**DEVIATION REQUEST
AND DECISION FORM IN
ASSOCIATION WITH A
REQUEST FOR A PUD
MODIFICATION FROM
THE ECM**

Project Name : Waterside
Schedule No.(s) : 71114-04-112
Legal Description : All of the waterside condominiums subdivision, recorded in Plat Book 2, At Page 47 Records of El Paso County, Colorado

WATERSIDE TOWNHOMES
 DEVIATION REQUEST - ECM SEC. 2.2.4.B.7.
 FIGURE 2-17, TABLE 2-7
 PCD FILE NO. PUDSP-22-009

PROPOSED TYPICAL SECTION – PRIVATE ROADWAY TRACT

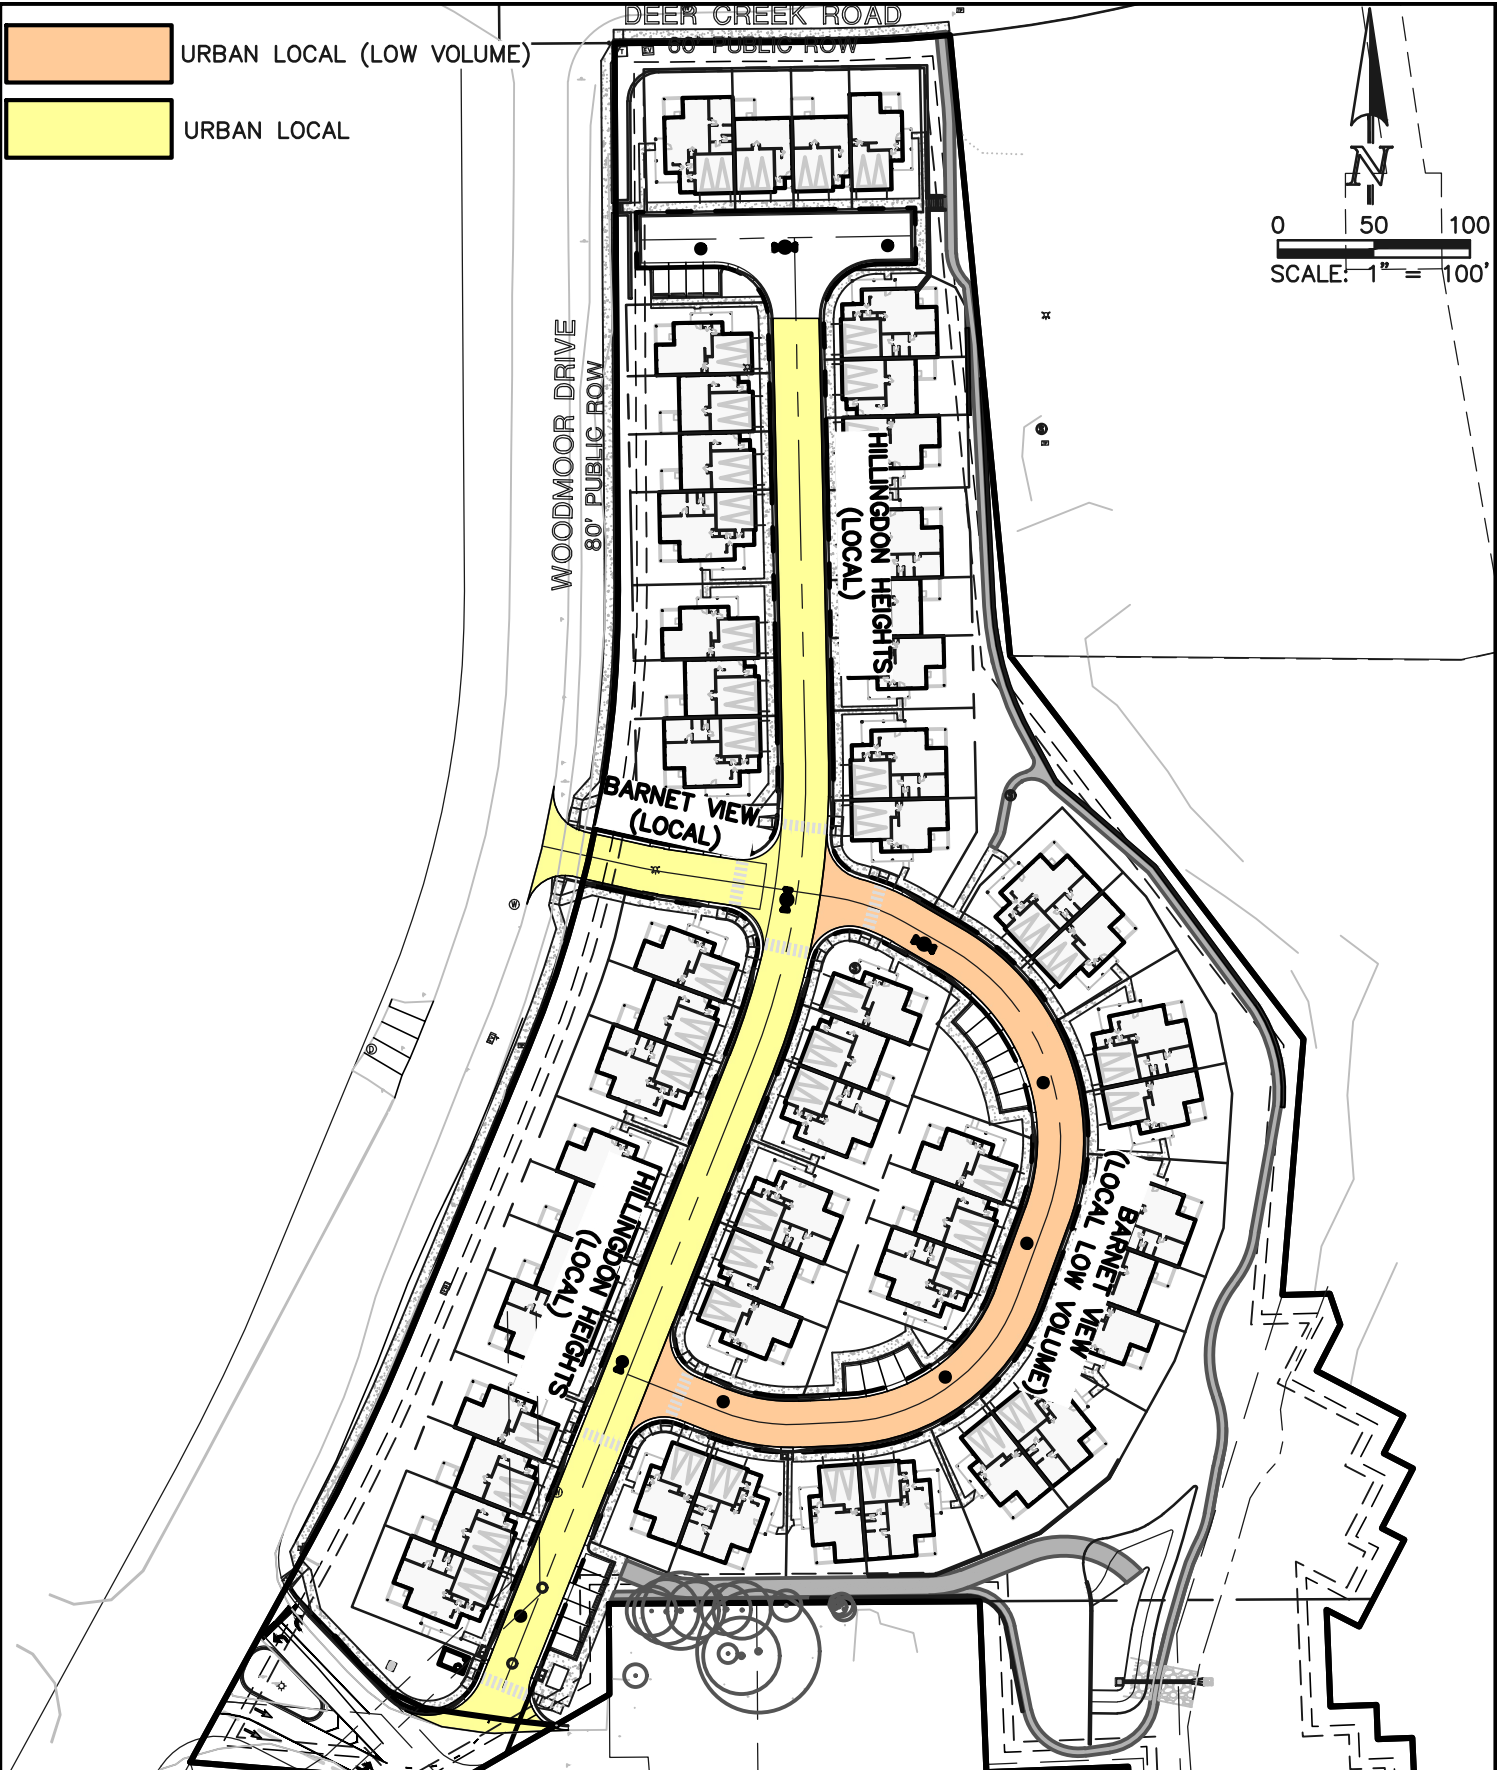
A deviation from the standards of or in Section **ECM2.2.4.B.7 (Figure 2-17), Table 2-7, ECM 2.3.3.F.3 and standard detail SD_2-2** of the Engineering Criteria Manual (ECM) is requested.

Typical urban local cross section (50' ROW with 30' asphalt mat) – ECM 2.2.4.B.7 (Fig. 2-17)

200' minimum tangent length between two Broken Back curves – ECM2.3.3.F.3

A standard county public urban local roadway is contained within a 50' wide public right of way (with a 30' wide asphalt mat). The proposed private street section is contained within a 29' wide private tract (owned and maintained by the Homeowners Association) and includes a 24' wide asphalt mat. All private roads to be built using county standard curb and gutter, signage and pavement thickness, as well as adhering to county maximum grade criteria. See attached proposed street section, and exhibit depicting locations of urban local and urban local (low volume) private roads. Broken Back curve tangent lengths of 30.07' and 36.58' are proposed on the small looped private Barnet View, where 200- minimum tangent length is required (same as an arterial roadway).

The unique community attributes include preservation of open space and vegetation that is the result of the private street use with shorter broken back tangent lengths which results in a more compact street network.

–HILLINGDON HEIGHTS – URBAN LOCAL ROADWAY (MIN. 200' CL RADIUS)

–BARNET VIEW BETWEEN WOODMOOR DRIVE AND HILLINGDON HEIGHTS –
URBAN LOCAL ROADWAY (MIN. 200' CL RADIUS)

–BARNET VIEW EAST OF HILLINGDON HEIGHTS – URBAN LOCAL (LOW VOLUME)
(MIN 100' CL RADIUS)

–16 HOMES = 160 ADT < 300ADT

–NO TANGENT LENGTH MINIMM FOR LOCAL (LOW VOLUME) IDENTIFIED IN ECM
